ADC PARKS & GREENSPACE ARBORICULTURE

PLANNING APPLICATION: A/115/15/DOC

ADDRESS: Former Pound Nursery Roundstone Lane Angmering

BRIEF DESCRIPTION: Application for approval of matters reserved by condition imposed under A/167/14/PL relating to conditions 4, 13, 14, 18, 20 & 23 for protection of retained trees, programme of archaeological work, ecological mitigation report, foul water sewerage disposal, surface water drainage & storage of refuse & recycling bins.

Figure 2 Default specification for protective barrier

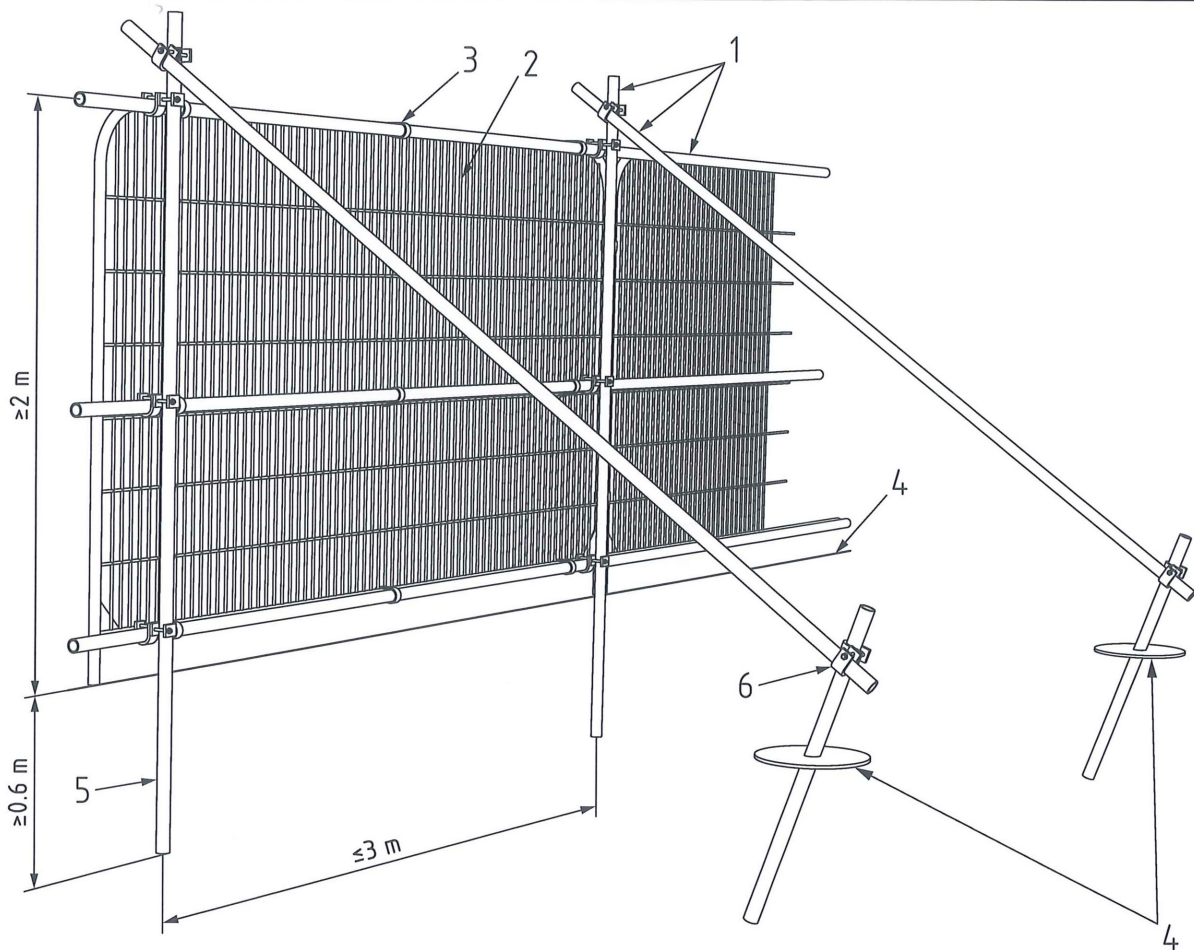
- Once the static protective fencing has been erected, the Local planning authority arboricultural officer must be contacted to ensure the fencing is correctly placed. This fencing must be erected and kept in place for the duration of the development works.
- The implication of effective ground protection must be achieved before any construction works commences to protect the given RPA. Again the local planning authority arboricultural officer must check this protection before the construction works commences.
- When excavating for the new developments foundations any root structure exposed with a diameter over 25 mm should be retained. If the operators wish to remove roots of over 25mm in diameter, then the LPA arboricultural officer must be informed to supervise any root pruning/removal.
